**In the matter of:
July 17, 2020 Water Quality Certification For Federal Permit Or License
for Yuba County Water Agency
Yuba River Development Project (FERC No. 2246)**

**YUBA COUNTY WATER AGENCY'S PETITION FOR
RECONSIDERATION OF JULY 17, 2020 WATER QUALITY
CERTIFICATION FOR FEDERAL PERMIT OR LICENSE**

**TECHNICAL MEMORANDUM ON
CONDITION 7 – NEW COLGATE POWER TUNNEL INTAKET**

**Stephen Grinnell, P.E. and
Paul Bratovich, Dianne Simodynes and James Lynch, HDR, Inc.**

Figure 3-30. New Bullards Bar Reservoir elevations in 2012–2016 as they relate to potential use of the upper intake at New Bullards Bar Dam (Source: CDEC, 2018, as modified by staff).

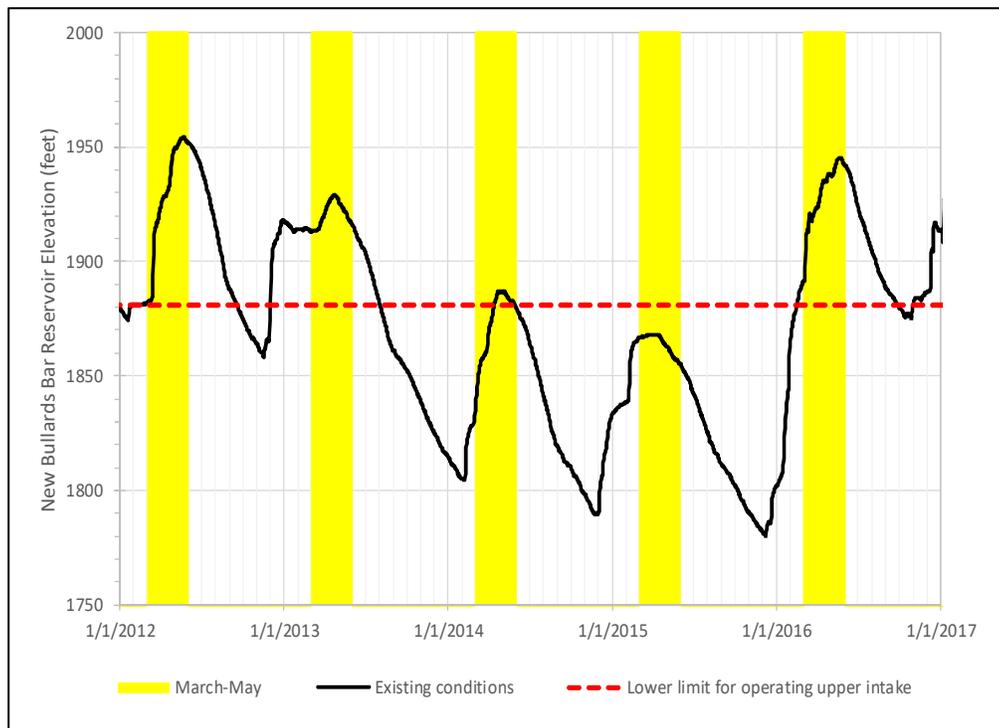
First, FERC and USACE were concerned that the upper intake would not be physically accessible when CDFW and DOI recommend its use because the New Bullards Bar reservoir water surface elevation would be lower than the invert for the upper intake in portions of those months. FERC and USACE conducted that analysis and at pages 3-112 of the Final EIS, they concluded:

The reservoir level would limit operation of the upper intake more often in March than in April and May, with greater limitations in other months, generally increasing through the summer months, and in relatively dry years or years following dry years.

In addition, as requested by CDFW and DOI, FERC and USACE also evaluated use of the upper intake in the extended drought from 2012 through 2016 and potential effects on lower Yuba River temperatures. Following this analysis, FERC and USACE concluded:

As noted in comments on the draft EIS by the Water Board (2018a) and California DFW (2018), the 2012–2016 period includes a series of very low-flow years that resulted in 7-day average of the daily maximum temperatures in the lower Yuba River that were not suitable for various salmonid lifestages in 2014 and 2015. In response to requests to evaluate this extended drought, we analyzed if New Bullards Bar Reservoir elevations would have supported use of the upper intakes and used this information to evaluate potential effects on lower Yuba River temperatures. Figure 3-30 shows that reservoir levels would support use of the upper intake any time in March through July of 2012, 2013, and 2016. However, the reservoir level would prevent use of the upper intake in 2014 during about half of the March–May period that FWS [DOI] and California DFW recommend, and on all days from May 29, 2014, through February 16, 2016. These limitations on operating the upper intake in March–May of 2014 and 2015 demonstrate the inability of using this strategy to cool the lower Yuba River during latter years of similar multi-year droughts.
